CLYDE FUEL SYSTEMS LTD.,

DIAG. ARRANG^t OF STEAM JET SYSTEM OF OIL BURNING FIRING THRO^g FIRING DOOR OF COCHRAN CROSSTUBE BOILER.

FILING No. 6A	DRAWING No.
DRAWN BY C.B.	15606
CHECKED BY	
DATE 20.12.50

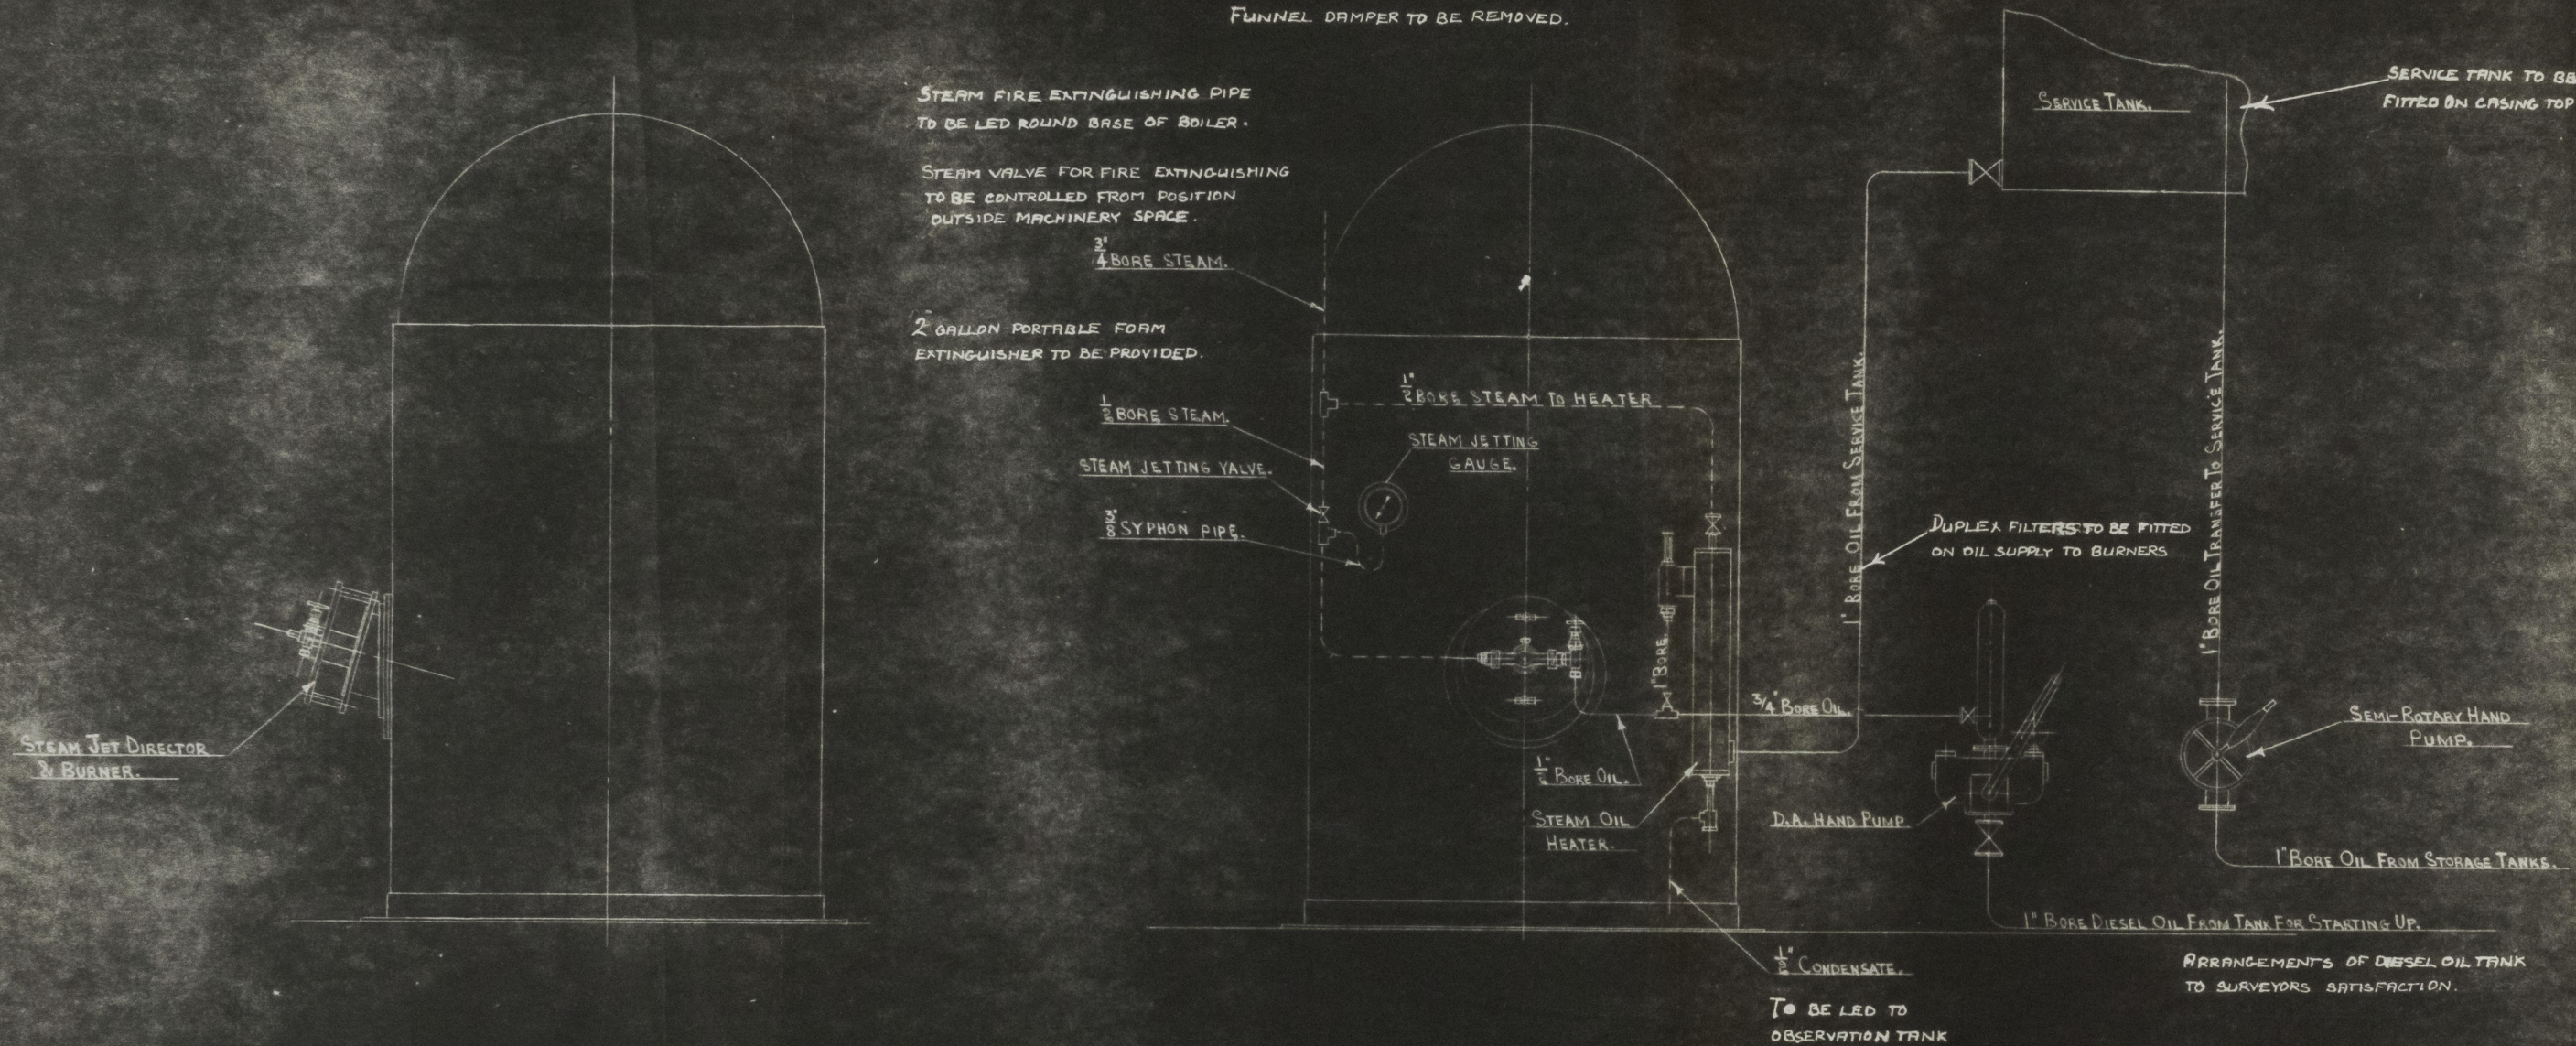
FUNNEL DAMPER TO BE REMOVED.

The flush point of the oil fuel to be above 140° F.

The remaining requirements of the Rules for Pumping and Piping to be complied with as far as they are applicable.
